FINAL PLAT HIGH PLAINS FILING NO. 1 A PORTION OF THE SOUTHWEST QUARTER OF THE SOUTHEAST QUARTER OF SECTION 19, TOWNSHIP 11 SOUTH, RANGE 65 WEST OF THE 6TH P.M., COUNTY OF EL PASO, STATE OF COLORADO

Markup Summary

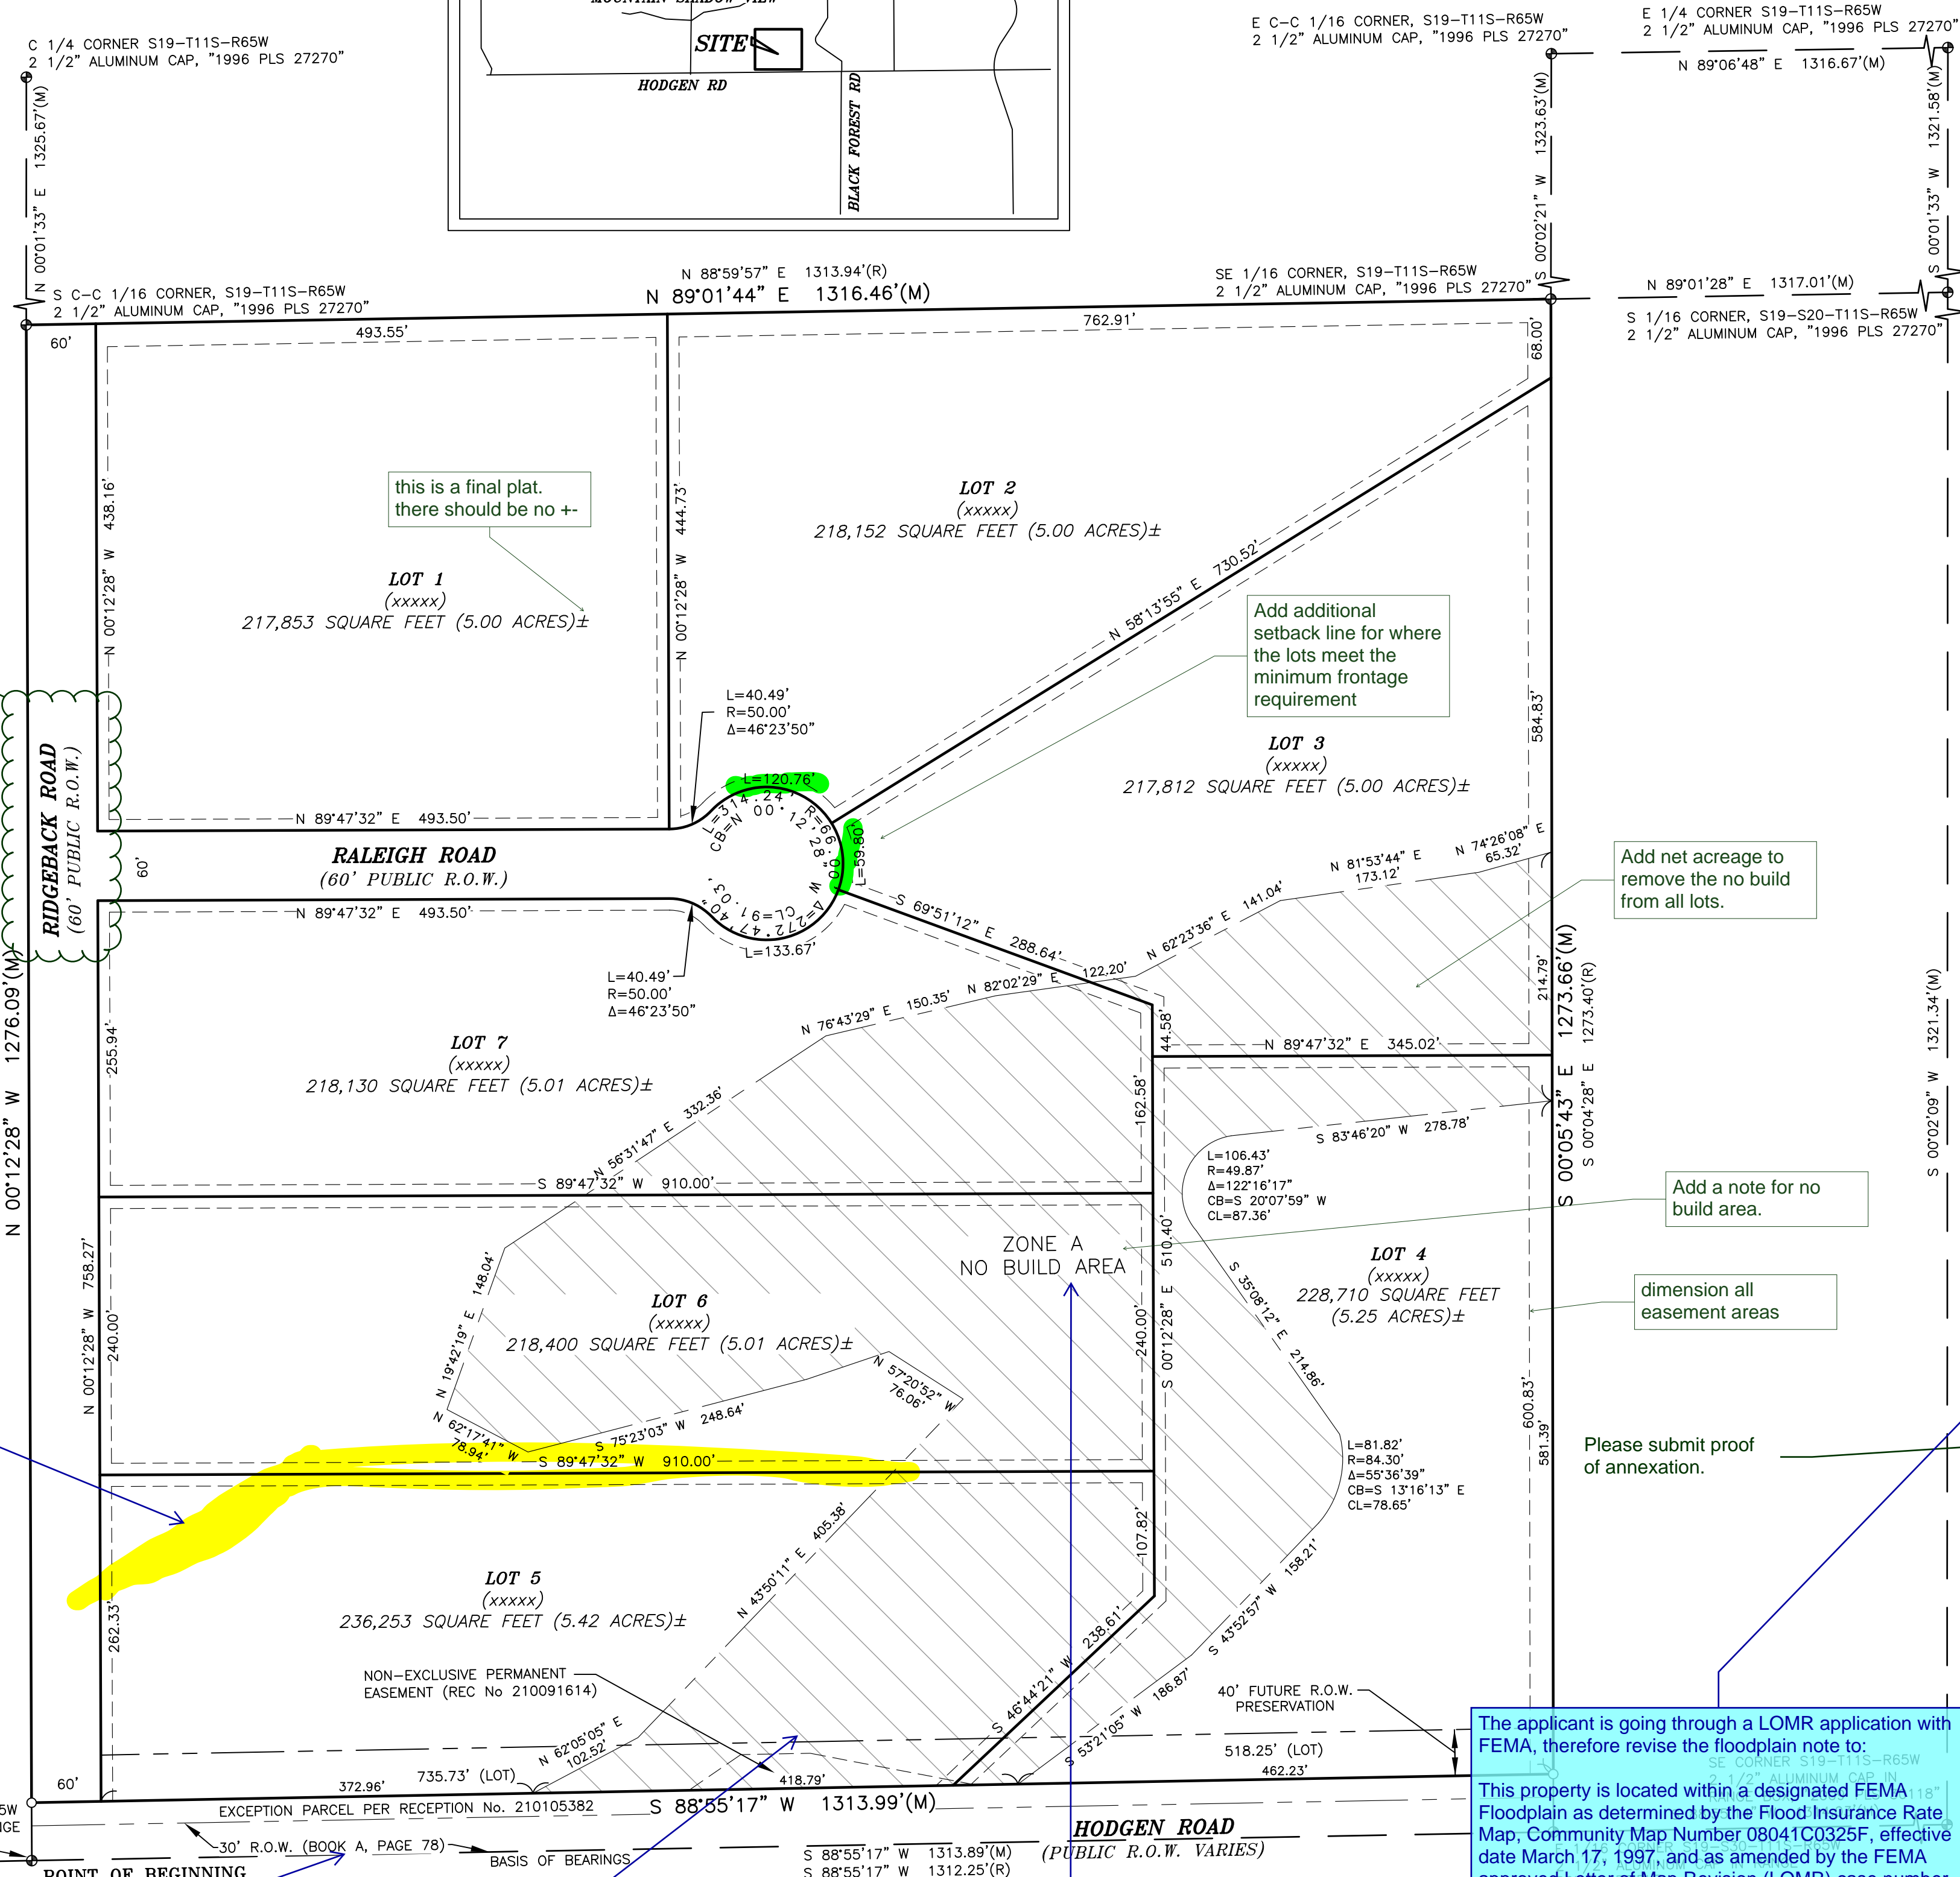
Provide a drainage easement for the open channel. Coordinate with the Design Engineer regarding the required width. See ECM Section 3.3.3.K for easement criteria.

Update label or provide a note that formalizes dedication of the prescriptive ROW to the County.

Per LDC 8.4.2.B.1.e, show the FEMA approved base flood elevation on the plat.

Update to "No Build" and "No Storage of Materials" area. Coordinate with the design engineer. a. With the LOMR the zone designation is likely to change to Zone AE. b. Show the FEMA 100yr based on the approved LOMR

this is a final plat. there should be no +/-

Add additional setback line for where the lots meet the minimum frontage requirement

Add net acreage to remove the no build from all lots.

dimension all easement areas

Add a note for no build area.

Per LDC 8.4.2.B.1.e, show the FEMA approved base flood elevation on the plat.

Update label or provide a note that formalizes dedication of the prescriptive ROW to the County.

The applicant is going through a LOMR application with FEMA, therefore revise the floodplain note to:

Update to "No Build" and "No Storage of Materials" area.

Coordinate with the design engineer.
 a. With the LOMR the zone designation is likely to change to Zone AE.
 b. Show the FEMA 100yr based on the approved LOMR

Provide a drainage easement for the open channel. Coordinate with the Design Engineer regarding the required width. See ECM Section 3.3.3.K for easement criteria.
